UNITED STATES PATENT AND TRADEMARK OFFICE

APPLICATION NO.	FILING DATE	FIRST NAMED INVENTOR	ATTORNEY DOCKET NO.	CONFIRMATION NO.
10/670,143	09/24/2003	Michiel Peter Oderwald	Vereenigde P59US	9163

Office Action Summary

DETAILED ACTION

Claim 3:

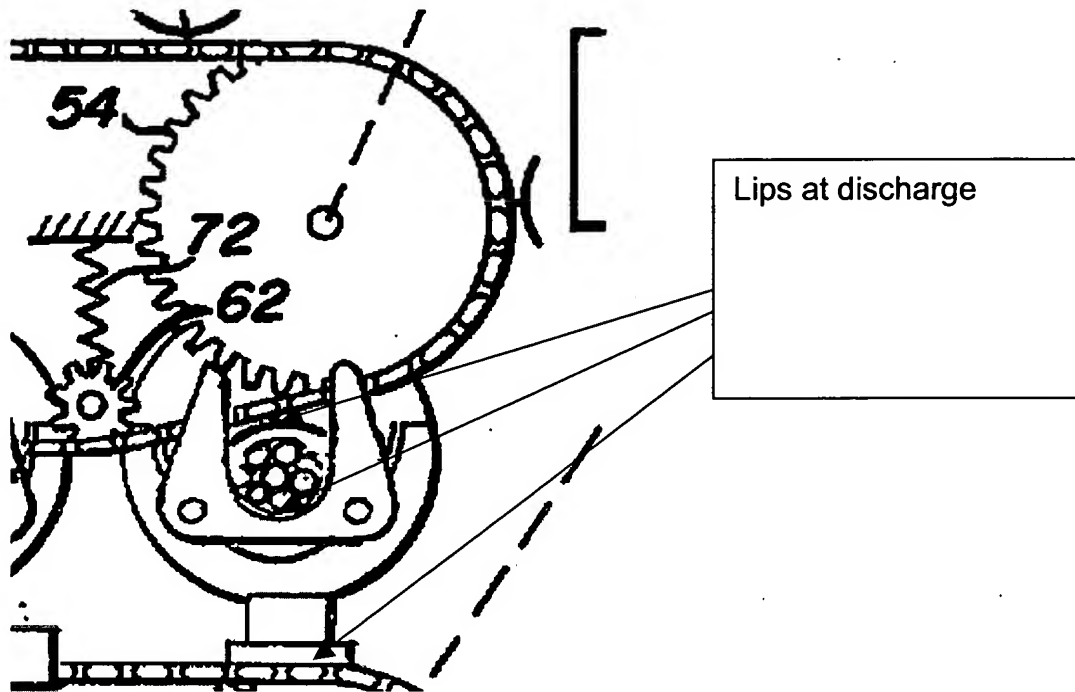
Pair of lips resiliently pressing **substantially** against each other at discharge & stems pushed away:

claims 4, 12:

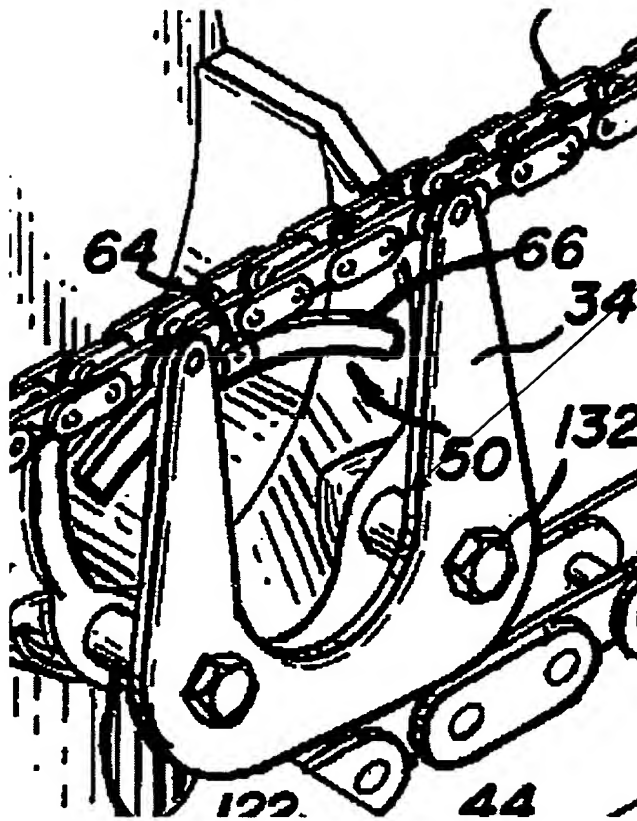
an upholder with a point of connection:

Upholder (inside the finger)
connected to a part of the band
